## FILE NOTE

**Project/Site:** 82 Fitzjohn Avenue, Hampstead

**Meeting Date:** 21<sup>st</sup> June 2023

### **PURPOSE OF THE MEETING:**

*Plate 9 - TPF adjacent T13 – T19*

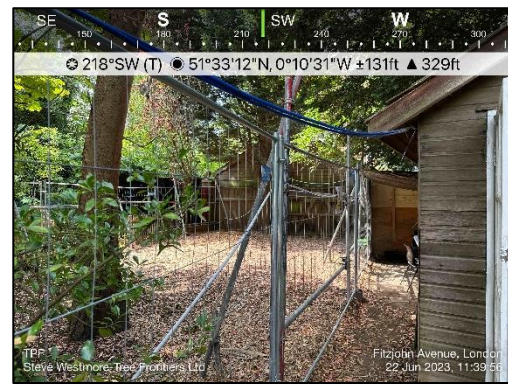
- 1.1. Tree Protective Fencing (TPF) has been erected and maintained in accordance with the approved arboricultural documents and appropriate signs have been attached (see Plates 1 – 10 below). The fencing consists of either scaffold frame with Heras 151 panels attached, or Heras 151 in rubberised feet, or utilising a rear stabilising strut for stability.

- 2.1. SW noted that the mitigation measures that had been proposed to alleviate compaction damage from breaches of the Construction Exclusion Zones (CEZ) had been completed. This includes decompaction of the rooting environments and introduction of bark mulch to improve the site conditions. This is evident behind the TPF in Plates 6-10 above.

*Plate 11 – Proposed TPF variation adjacent T10 (indicative relocation identified with red dashed line with area to left removed from CEZ)*

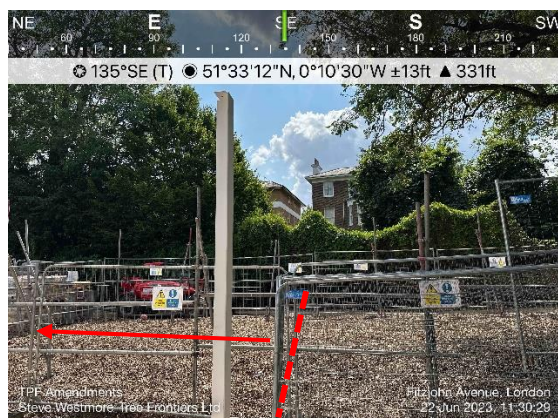
- 3.1. JD indicated that a significant section of TPF had been erected to the east of T10 (Ash), in accordance with approved documents, but queried the extent of the TPF as it is well beyond the tree canopy and Root Protection Area (RPA). SW agreed that the TPF in this area does not provide any additional protection to this tree and that an adjustment would not detract from the necessary protection measures (see Plates 11 & 12 below), but that liaison with the LPA would be required before amendments could be undertaken.

- 3.2. SW advised JD that a revised TPP would be prepared that provides further clarity on tree protection measures. SW further advised that any revised plan would need written confirmation from the Local Planning Authority before the recommendations could be implemented as it would deviate from the approved documents.

- 3.4. SW confirmed he would liaise with Camden Council and seek to get the new tree protection measures agreed in writing as swiftly as possible.
- 3.5. The proposed variations are best interpreted through the graphical representation on the TPP, but a summary is as follows:

- Remove redundant TPF adjacent to T10 that is neither protecting the RPA nor canopy; and
  - Utilise existing close-board fencing as TPF, with Heras 151 system tied into, to create CEZ.
